**TOWN OF BAY HARBOR ISLANDS
MORRIS N. BROAD COMMUNITY CENTER
1175 95TH STREET
BAY HARBOR ISLANDS, FL 33154**

DEVELOPMENT & REVIEW COMMITTEE MEETING

**TOWN OF BAY HARBOR ISLANDS
COMMUNITY DEVELOPMENT
MEMORANDUM**

Subject: Site Development Plan Application
9761 West Bay Harbor Drive– 6 DU Townhouse Complex
Bay Harbor Luxury Townhomes
Bay Harbor Islands Acct. No. SPR2024-000021
MMPA Acct. No. 01-0702-1196

SITE DRAINAGE PLAN

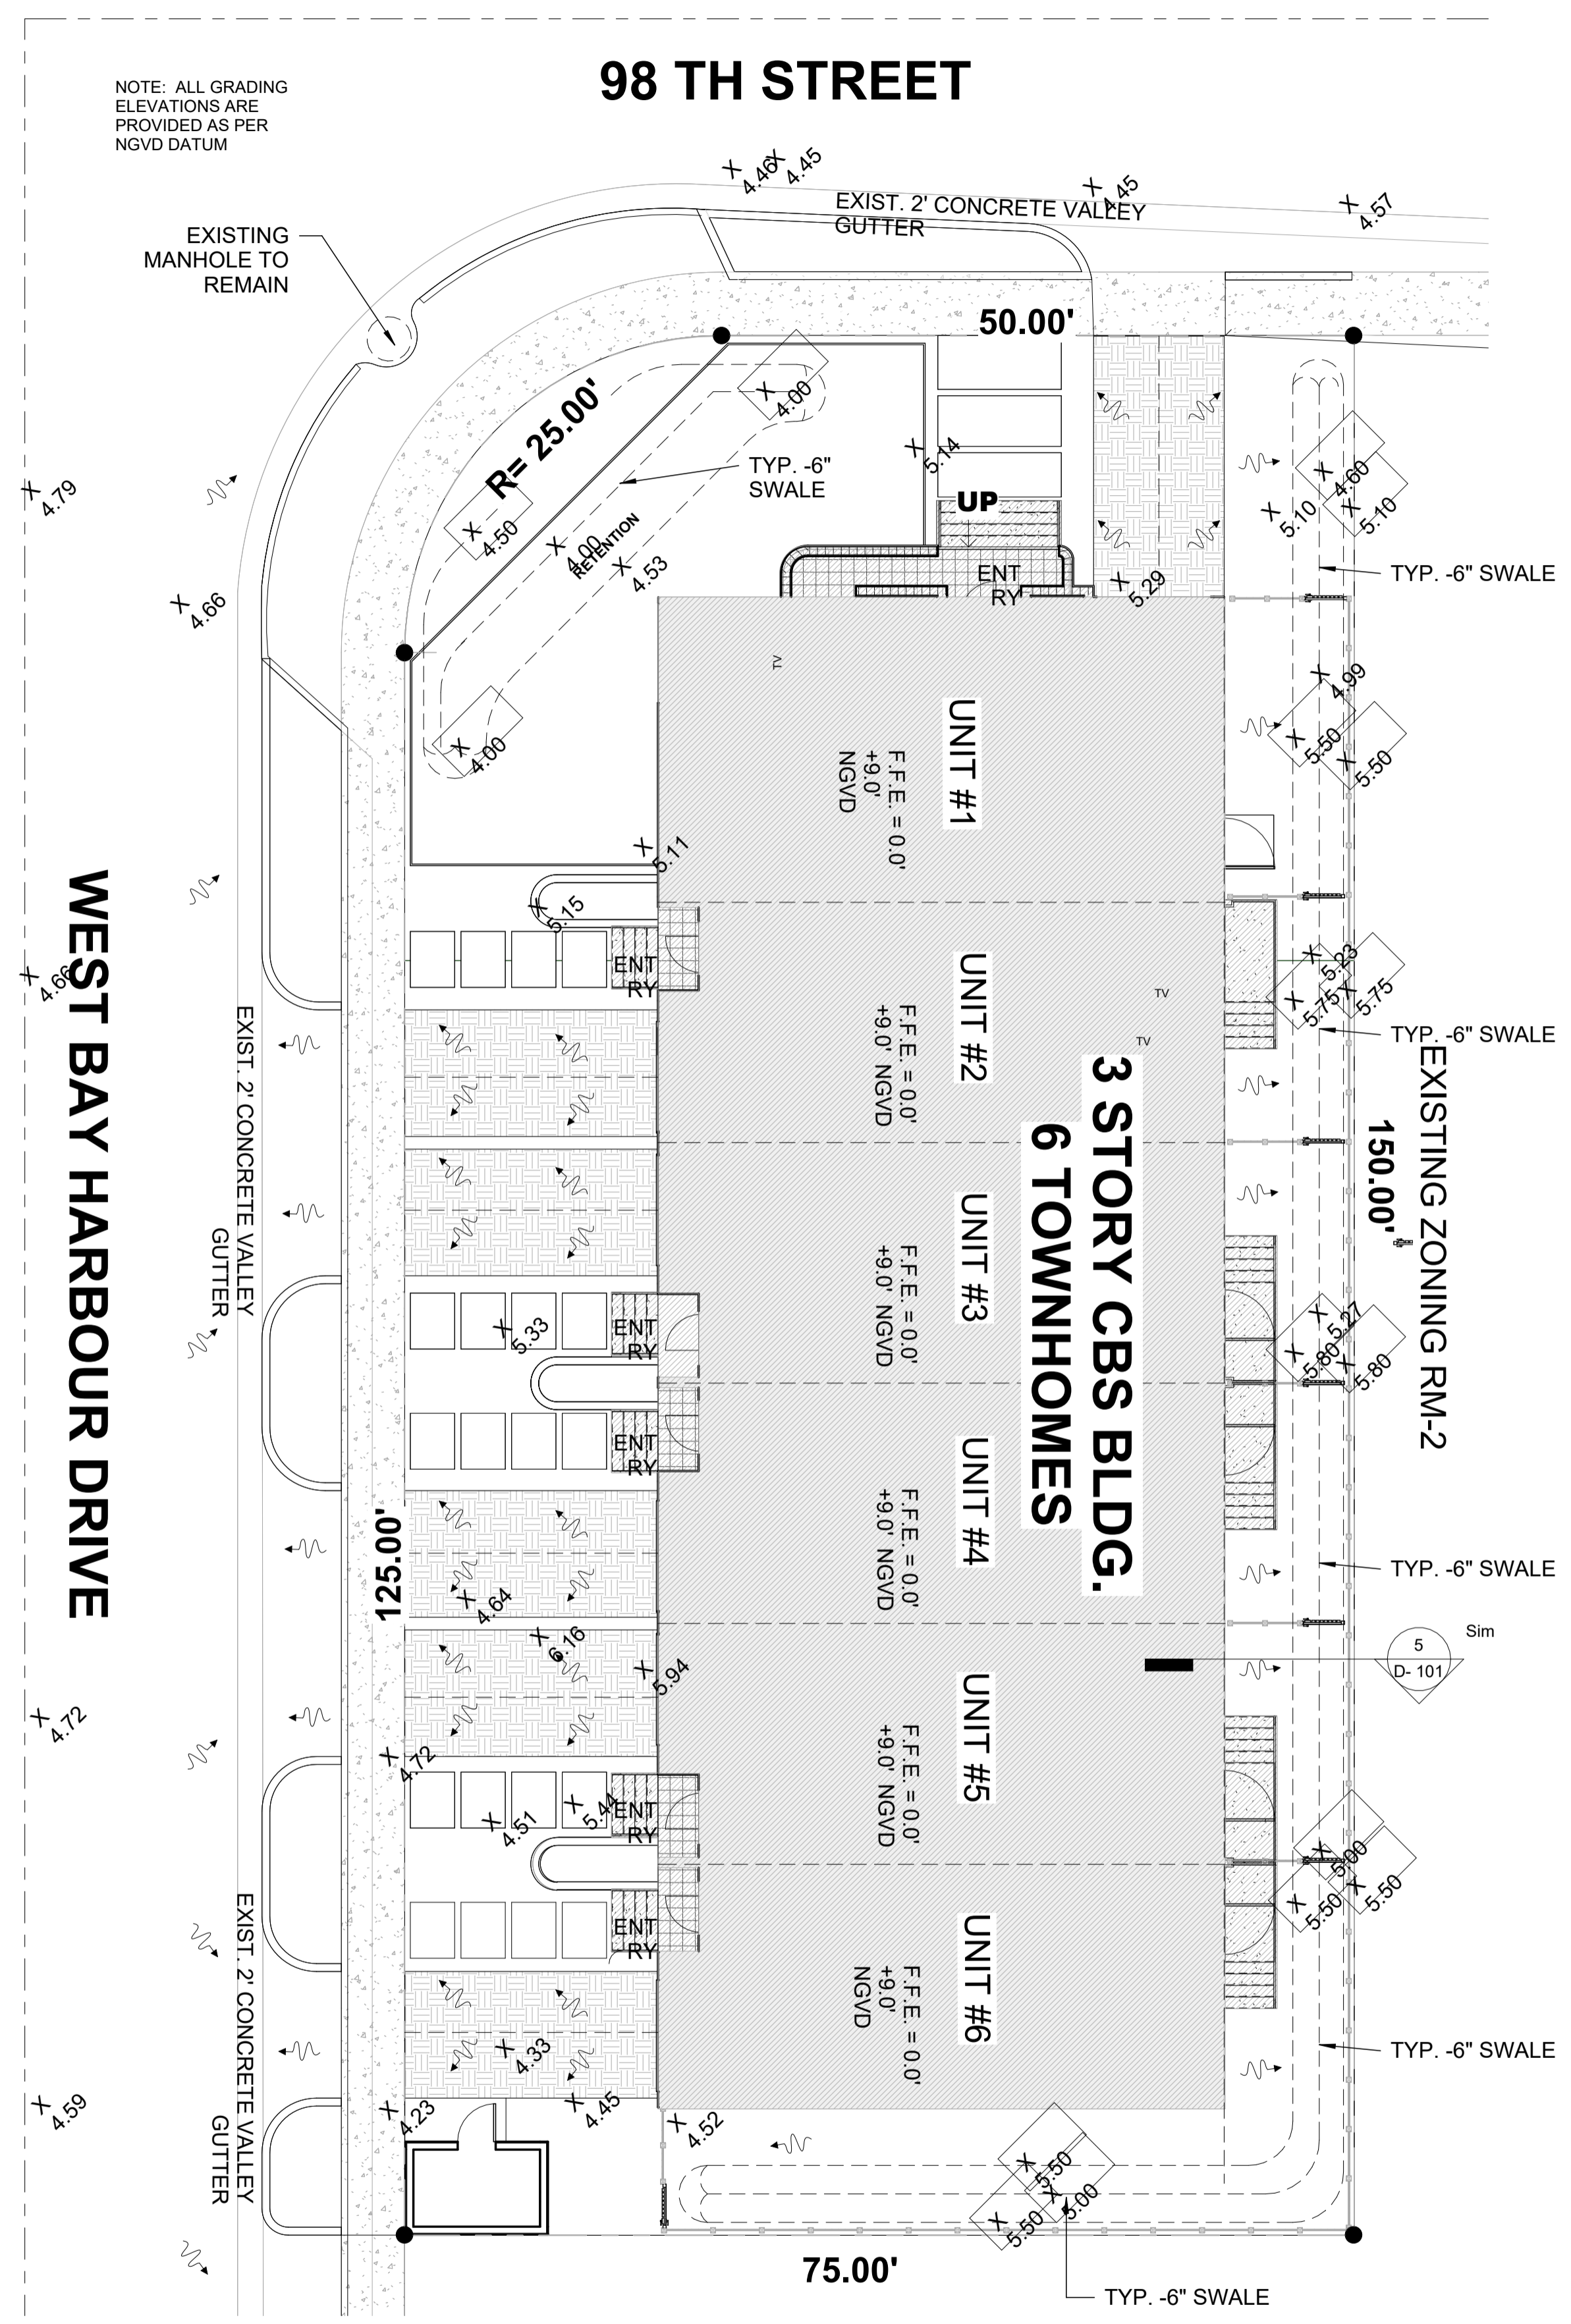
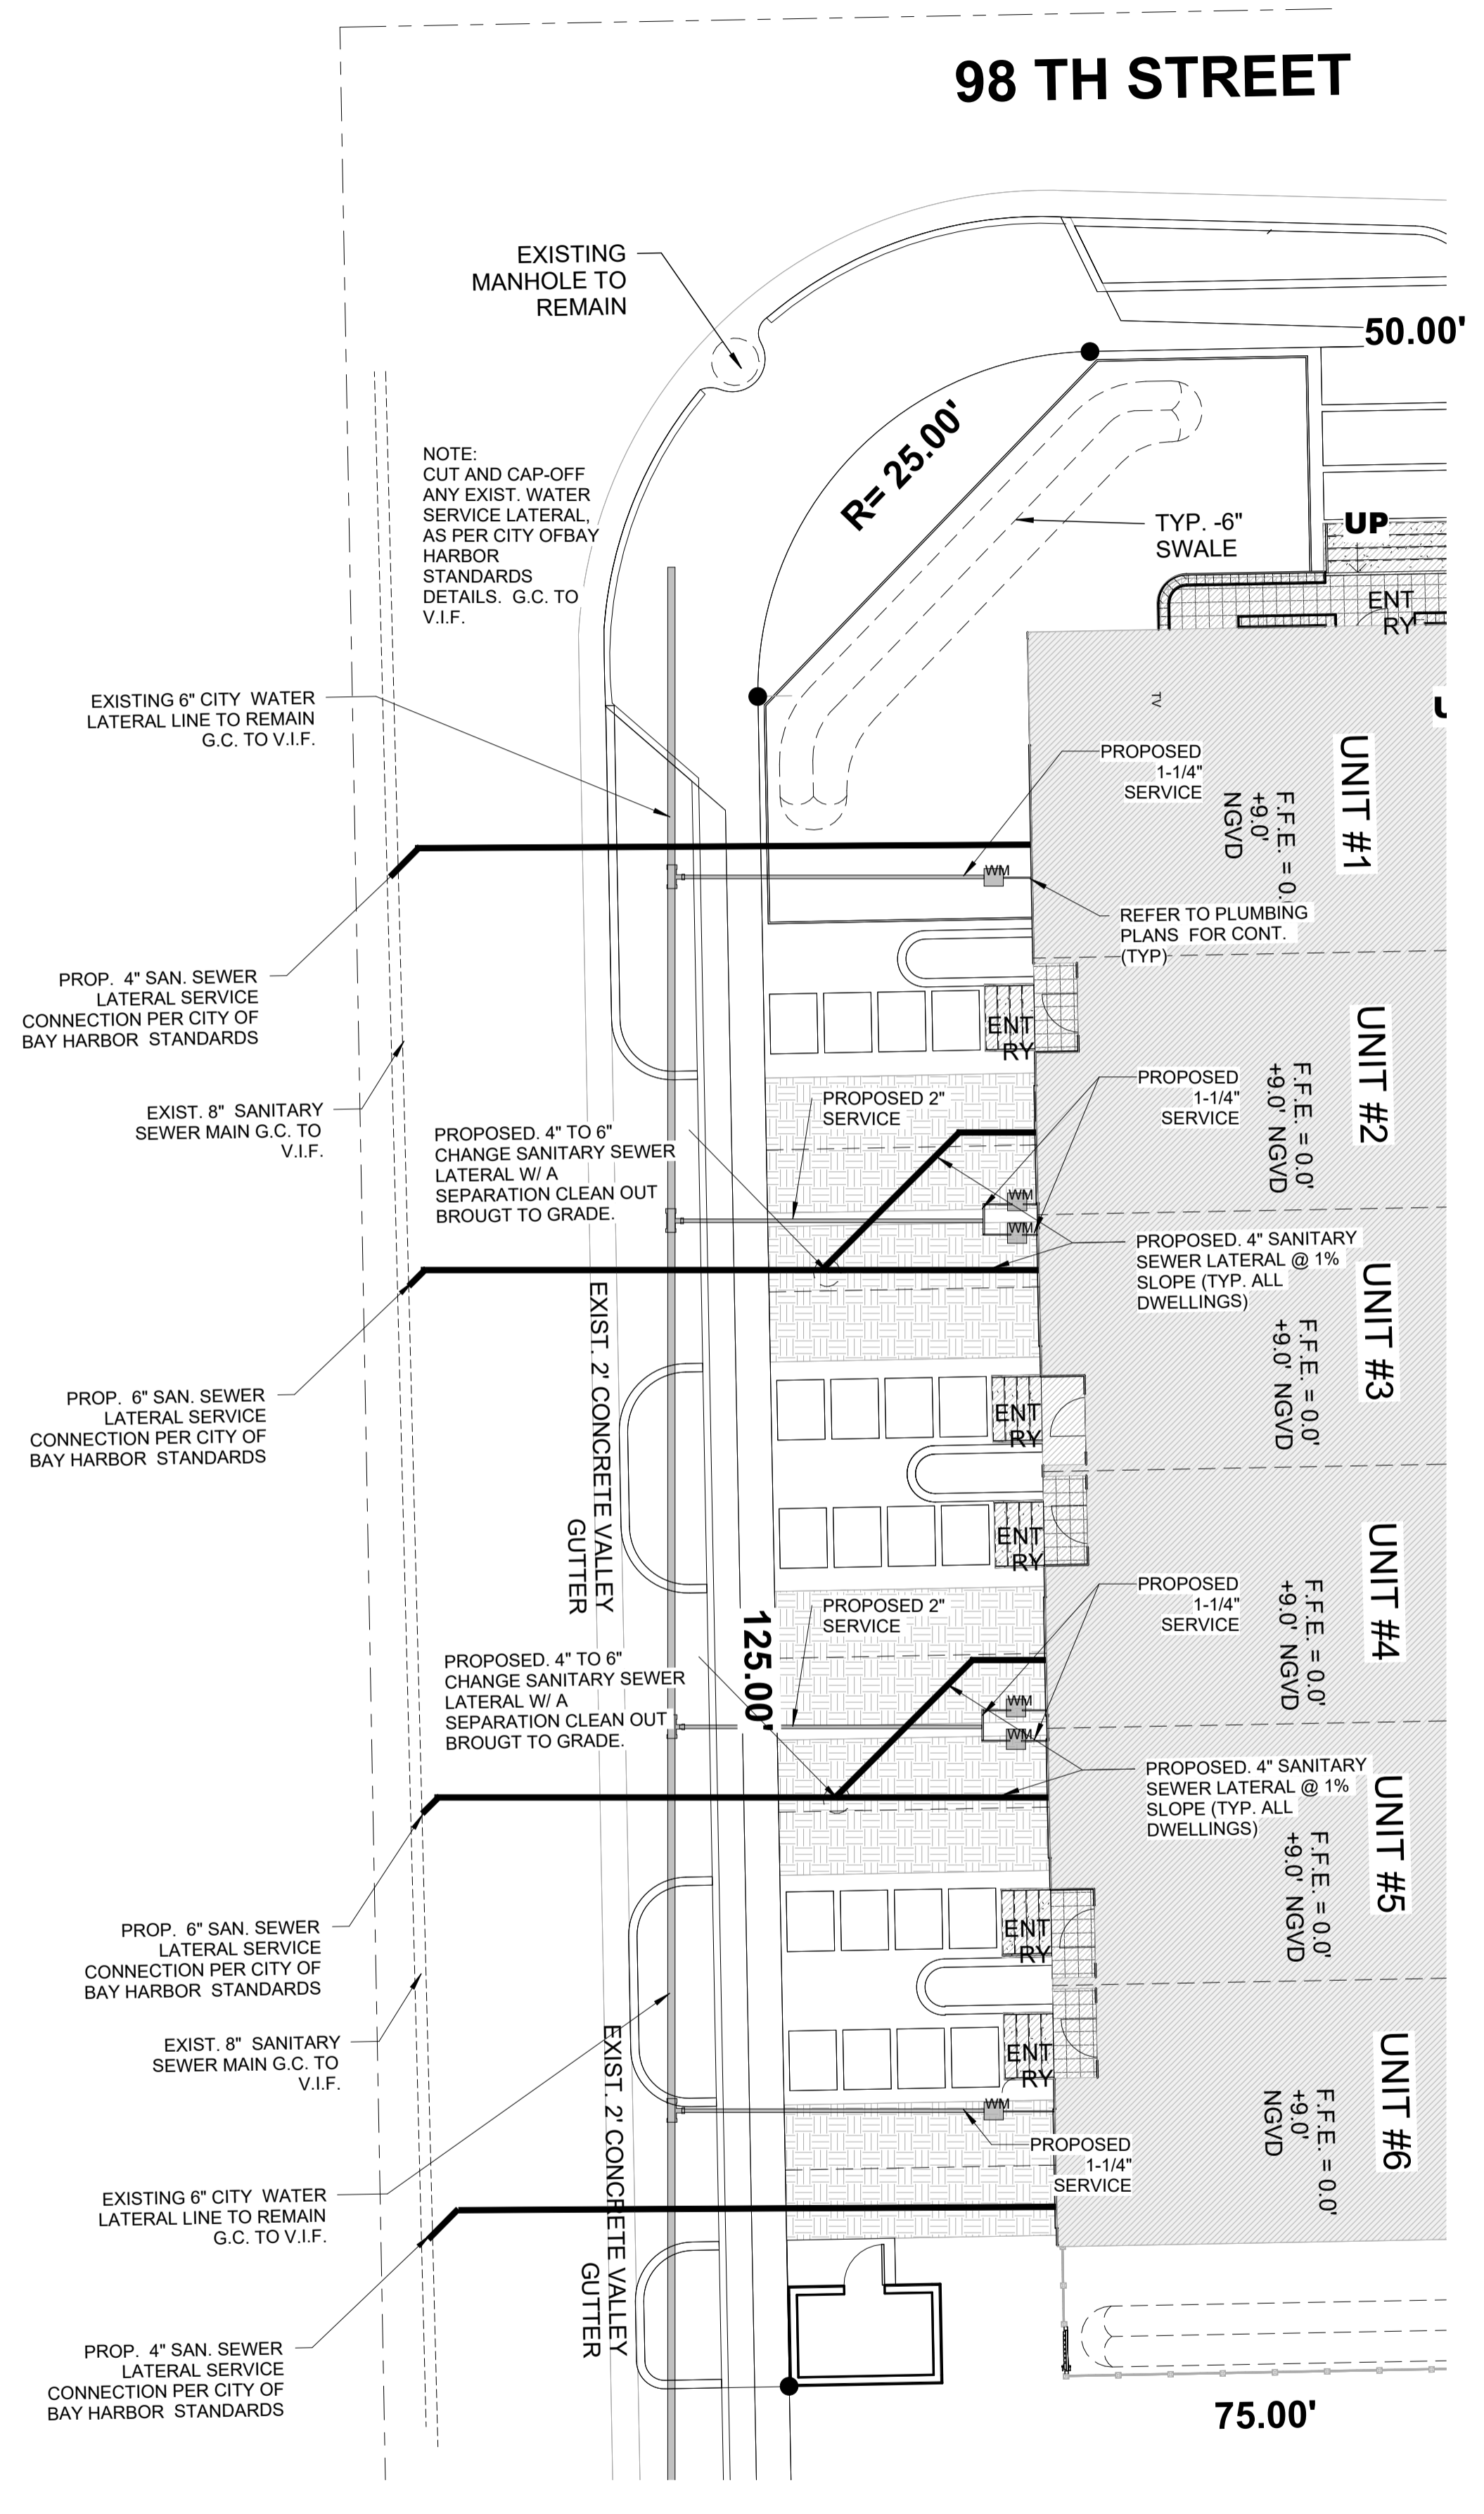
- 12) A Civil Engineering plan was submitted as required. The plan is not clear how storm water will be kept on site. Need preliminary calculations.
